PG&E Letter DIL-03-003

Docket No. 72-26
Diablo Canyon Independent Spent Fuel Storage Installation
Revised Response to NRC Request for Additional Information 5-1 for the Diablo
Canyon Independent Spent Fuel Storage Installation Application (TAC No. L23399)

Revised Response to Request for Additional Information for Diablo Canyon Independent Spent Fuel Storage Installation (ISFSI) License Application

Question 5-1

SAFETY ANALYSIS REPORT
DIABLO CANYON ISFSI
FIGURE 4.2-2
EMBEDMENT ANCHORAGE
STRUCTURE

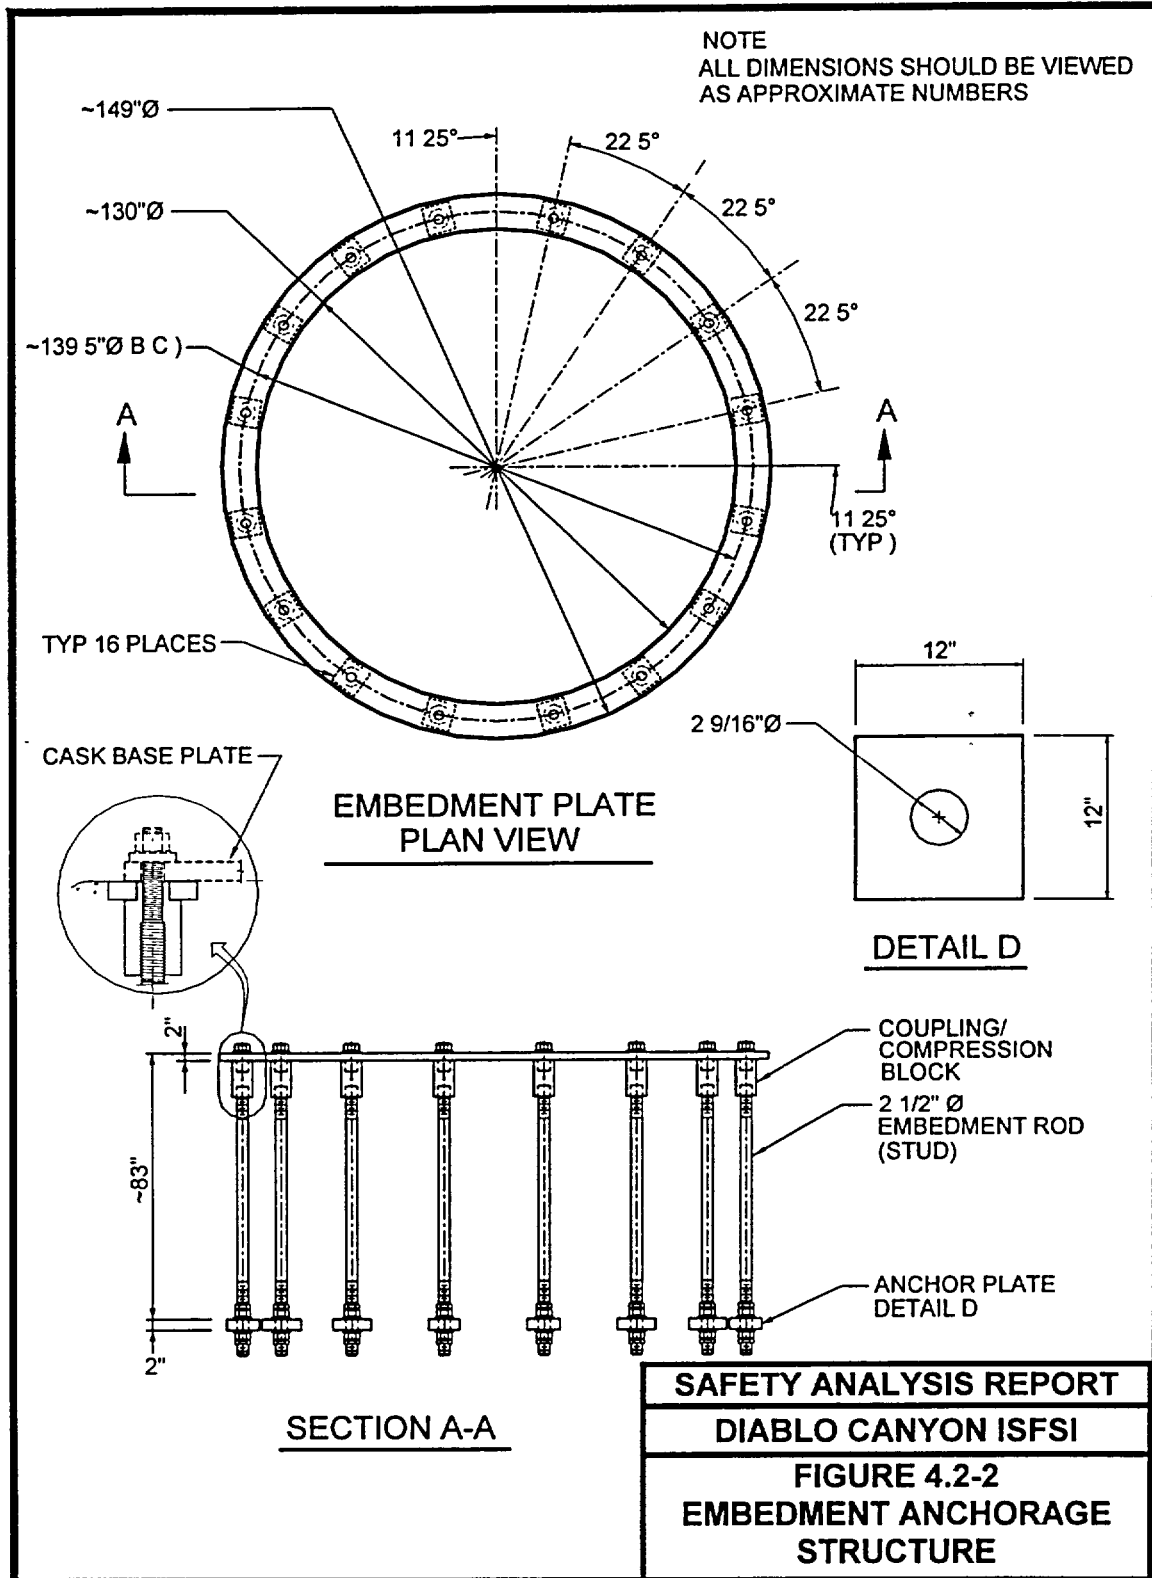
Provide an evaluation to support the conclusion that the concrete will not break out of the storage pads prior to failure of the ductile metal members.

The Diablo Canyon ISFSI Safety Analysis Report (Section 3.3.2.3, ISFSI Concrete Storage Pad: Design Criteria) states that the design strength capacity of the embedded base plate, concrete bearing, and diagonal tension shear capacity are in accordance with the design provisions of American Concrete Institute 349-97 and the embedded anchorage will meet the ductile anchorage provisions of the Proposed Draft New Appendix B to American Concrete Institute 349-97 (dated October 1, 2000). Supporting evidence that the concrete will not break out prior to failure of the ductile metal members is not provided in the Diablo Canyon ISFSI Safety Analysis Report. An evaluation of concrete breakout strength in tension of a group of anchor rods considering spacing and edge distance should be provided.

- (a) The tension pull-out load was to be carried from the cask using 16 tension tie-rods (also referred to as round bars in Attachment 1) which would not only satisfy the stiffness requirements of design, but were designed to deliver the load to the concrete through upward compression imposed by a large 12-inch square plate (called the anchor plate in Attachment 1) attached at the lower end of these tension tie-rods (see draft Diablo Canyon ISFSI SAR, Figure 4.2-2 (Enclosure 2 to this submittal)). This upward compression load into concrete would in turn, be resisted by concrete bearing and diagonal shear of the appropriate concrete section.

- (b) The imposed horizontal shear load was to be delivered into concrete by bearing action of the "coupler" mechanism, which is located at the top of the tension tie-rods, against the surrounding concrete. The shear load is then resisted by concrete through side bearing action. The tension tie-rods are not relied on to deliver any shear into the concrete as a typical anchor would.

The load path for the tension pull-out load from the cask into concrete is through 16 pre-loaded bolts, which are each, tied to a coupler at top of the concrete. This load is then transmitted through the coupler into what is called a tension tie-rod (also referred to as round bar in Attachment 1). These tension tie-rods are 2.5 inches in diameter and 71.13 inches in length (Attachment 1, Page 20). At the lower end of each tension tie-rod is a 12-inch square anchor plate (Attachment 1, Page 22, Section 6.4). The tension pull-out load is transmitted into concrete through the bearing action of the anchor plate as an upward compressive force against the concrete. This vertical compressive load can also be resisted by concrete as a diagonal shear through the ISFSI cross section and as a plug of concrete and reinforcing steel above each anchor plate evaluated using the shear-friction provisions of the Code.

Therefore this design would ensure that the tension tie-rods are the ductile element in the entire tension load path since its ultimate capacity of 220.34 kips is lower than design strength of the supporting anchor plate, and the various concrete strengths based on code equations reduced by appropriate ϕ factors. Furthermore, this ultimate tensile capacity of 220.34 kips was calculated based on the reduced section at the threaded root of the tension tie-rods (Attachment 1, Page 21) which is approximately 125 percent of the yield capacity of the unreduced gross section of the tension tie-rods computed as 176.72 kips (See Attachment 1, Page 21). These tension tie-rods are made of A36 steel, which has a well-defined yield plateau. Thus, if any overload occurs, the tension tie-rods will yield before any less ductile failure could occur, therefore ensuring a ductile behavior as intended by Appendix B of References 1 and 2.

the applied shear load is through the couplers at the top end of tension tie-rods into bearing resistance of the concrete. This check is done in Attachment 1, Pages 16 through 19, Section 6.2. As stated in Attachment 1, Page 19, the allowable shear load on the coupler as limited by concrete bearing is calculated as 1,350.4 kips, which is 260 percent of the demand shear load of 515 kips.
